UNITED STATES PATENT AND TRADEMARK OFFICE

| APPLICATION NO. | FILING DATE | FIRST NAMED INVENTOR | ATTORNEY DOCKET NO. | CONFIRMATION NO. |
|-----------------------------|-------------|----------------------|---------------------|------------------|
| 10/797,663 | 03/09/2004 | Michael E. Daniels | 4001-0018B (ZM0602) | 3929 |

Office Action Summary

DETAILED ACTION

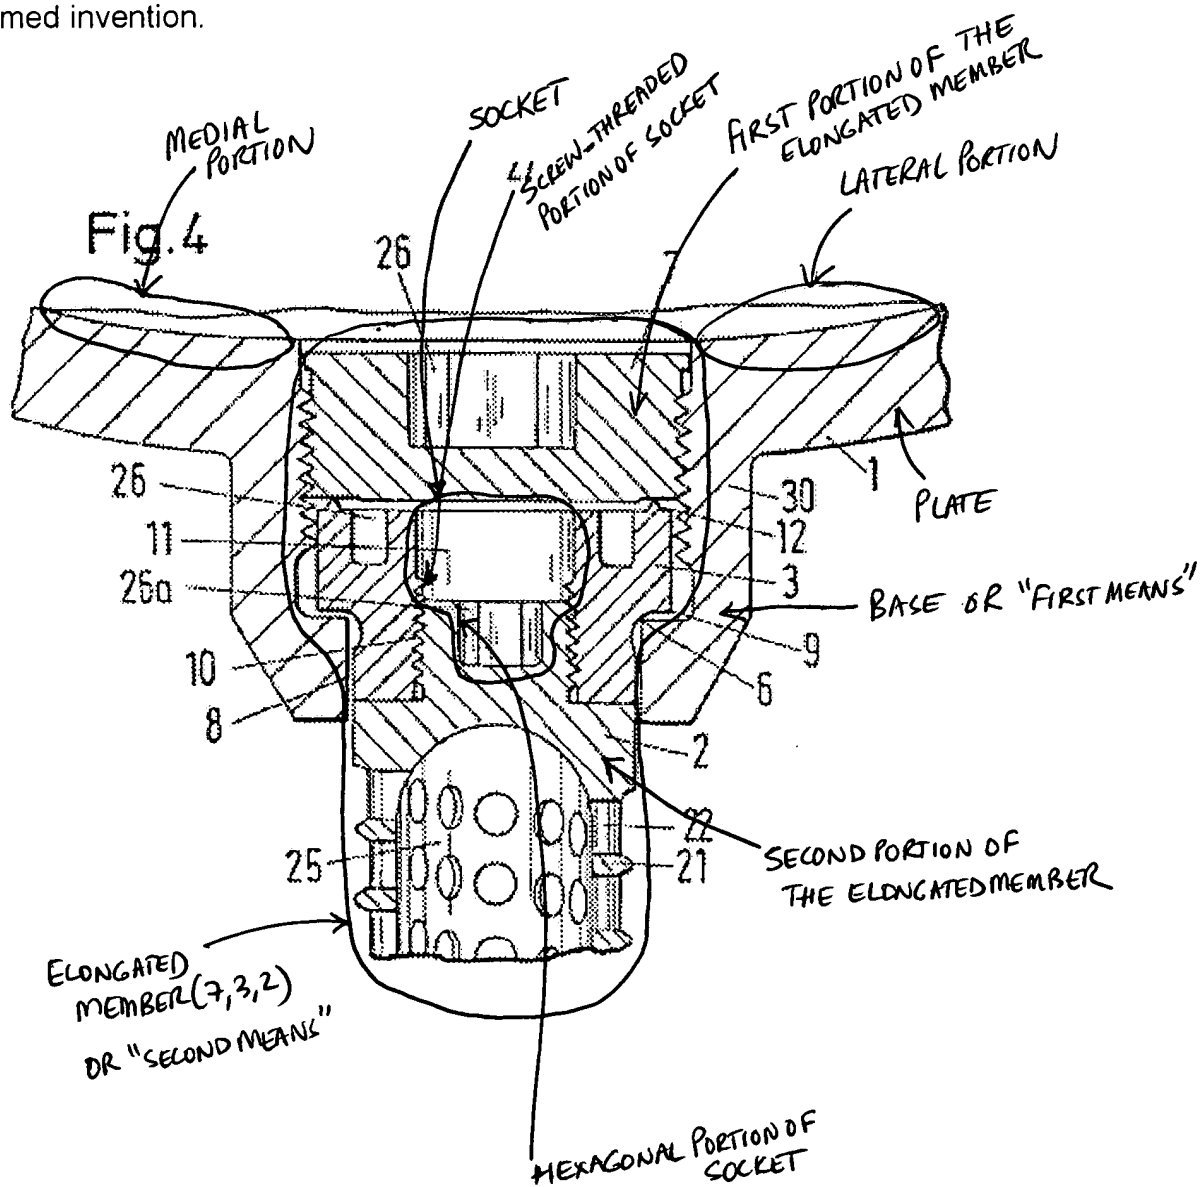
Claims 1, 3, 4, 8-11 and 19 are rejected under 35 U.S.C. 102(b) as being anticipated by Sutter et al. (US 6,102,951).

Sutter et al. disclose a tibial implant apparatus including: a shell or "plate" 1; a projection or "base" or "first means" 30 extending from the tibial plate; an anchoring element or "elongated member" or "second means" (7, 3, 2) including a first portion 7 and a second portion 2; a through passage or "channel" in the tibial plate and the base wherein the through-channel removably receives a first portion 7 of the elongated member from a point superior to tibial plate 1 and the second portion 2 of the elongated member extends away from base 30 (Fig. 4, col. 1, lines 17-23, col. 2, lines 31-55, and col. 3, lines 41-56). See Fig. 4 from Sutter et al. below, marked up to show elements of Applicant's claimed invention.

Sutter et al. disclose a tibial plate 1, a base 30 extending from the plate, and a socket defined in the elongated member (7, 3, 2) wherein the socket includes a hexagonally-shaped portion and a screw-threaded portion. See previous discussion of Sutter et al. and marked up Fig. 4 on page 6 of this action.

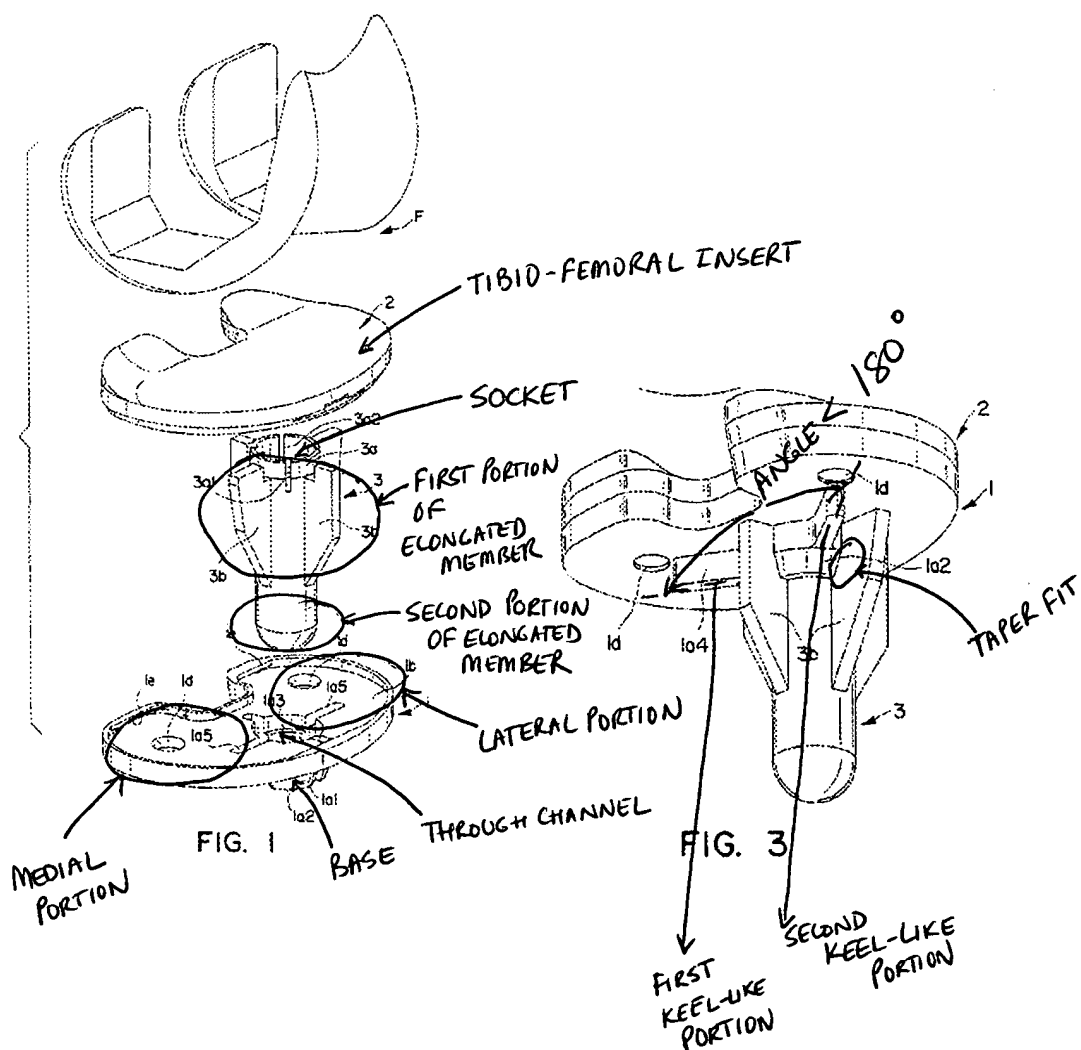
Claims 1-6, 8-9, 11-14 and 19-23 are rejected under 35 U.S.C. 102(b) as being anticipated by Delfosse (US 5,658,341).

Delfosse discloses a tibial implant apparatus including: a tibial socket or "plate" 1 having medial and lateral portions 160; a base 1a1 extending from the tibial plate; a stabilizing pin or "elongated member" 3 including a first portion and a second portion; a through passage or "channel" 1a in the tibial plate and base wherein the through-channel removably receives a first portion of the elongated member from a point superior to tibial plate 1, and the second portion of the elongated member extends away from the base; a tibial plate or "tibio-femoral insert" 2 coupled to the tibial plate 1 (Figs. 1 and 3, col. 2, lines 34-67 and col. 3). Also see Figs. 1 and 3 of Delfosse marked up below to illustrate features of Applicant's invention.

Regarding claims 5 and 12, Delfosse discloses base 1a2 to have first and second keel-like portions or "protuberances" 1a4 that extend radially outwardly relative to the through channel (col. 2, lines 50-51 and marked up Fig. 3 above).

Delfosse discloses all elements of the claimed invention except for an explicit reference to the angle between the first and second keel-like portions to be "about 180 degrees." See marked up Fig. 3 of Delfosse on page 7 of this action suggesting an angle less than 180 degrees between the first and second keel-like portions.
